Re: Draft Major Permit Modification to Reconstruct the Suckla Farms No. 1, Weld County,  
Colorado, Permit No. CO10938-02115, API No. 05-123-14291

**DRAFT MAJOR MODIFICATION  
APPENDIX A CONSTRUCTION PROCEDURE**

## **STATEMENT OF BASIS**

### **Draft Major Modification for Final Permit Renewal**

*Modified Diagram*  
 Suckla Farms #1 Disposal Well  
 SENW, 500 feet (ft.) from the south line and 2020 ft. from the west line, Section 10,  
 Township 1 North, Range 67 West, Weld County, Colorado  
 API No. 05-123-14291

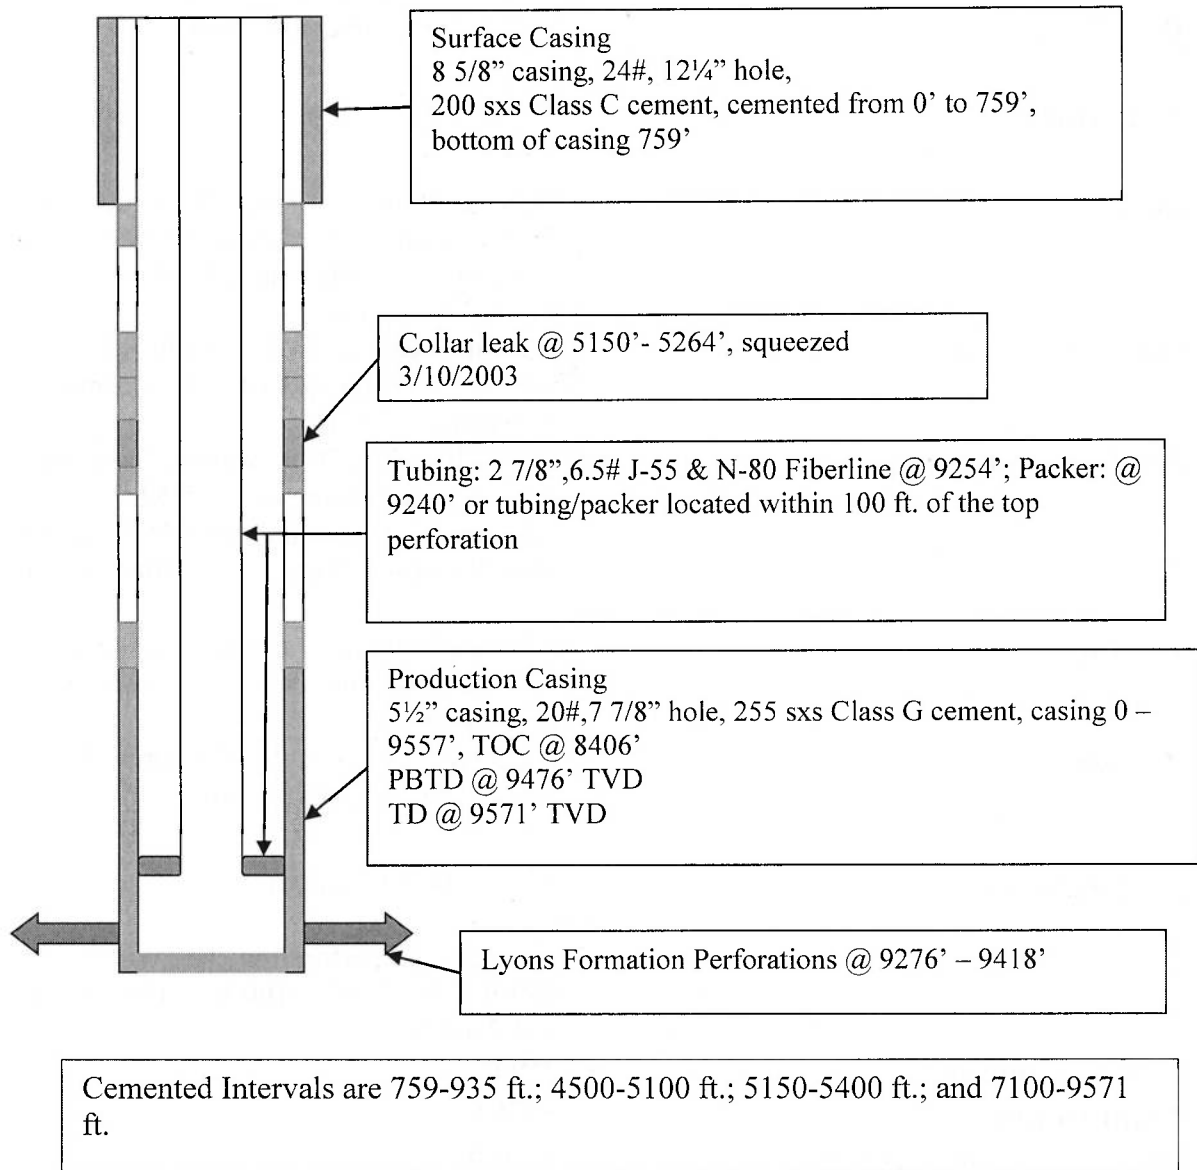
<b>CATEGORY</b>	<b>DESCRIPTION</b>
<b>Well Name</b>	Suckla Farms Injection Well #1
<b>API Number</b>	05-123-14291
<b>Location</b>	SENW, 500 feet (ft.) from the south line and 2020 ft. from the west line, Section 10, Township 1 North, Range 67 West, Weld County, Colorado
<b>Surface Casing</b>	8 5/8-inch casing, 24 lb. weight, 12 ¼ inch hole, 0 – 759 ft. depth of casing, cemented between 0 – 759 ft.
<b>Production Casing</b>	5 ½ inch casing, 20 lb. weight, 7 7/8-inch hole, depth of casing is 0 – 9557 ft.
	Cemented Intervals are 759-935 ft.; 4500-5100 ft.; 5150-5400 ft.; and 7100-9571 ft.
<b>Tubing</b>	2 7/8 inch Fiberline tubing, shall be set at 9254 ft. or within 100 ft. of the top open perforation
<b>Packer</b>	Packer shall be set at 9240 ft. or within 100 ft. of the top open perforation
<b>Perforations</b>	9276 – 9418 ft. (open)  All squeezed perforations below: 759-935 ft.; 4500 - 5100 ft.; 5150-5400 ft.; and 7100-8406 ft.

<b>Top of Cement</b>	759 ft.
<b>Total Depth</b>	9571 ft.
<b>Plug Back Total Depth</b>	9476 ft.
Depths are approximate and will be verified with a Cement Bond Log (CBL) following the completion of all well reconstruction activities. A well completion form and Part I mechanical integrity test results will also be required.
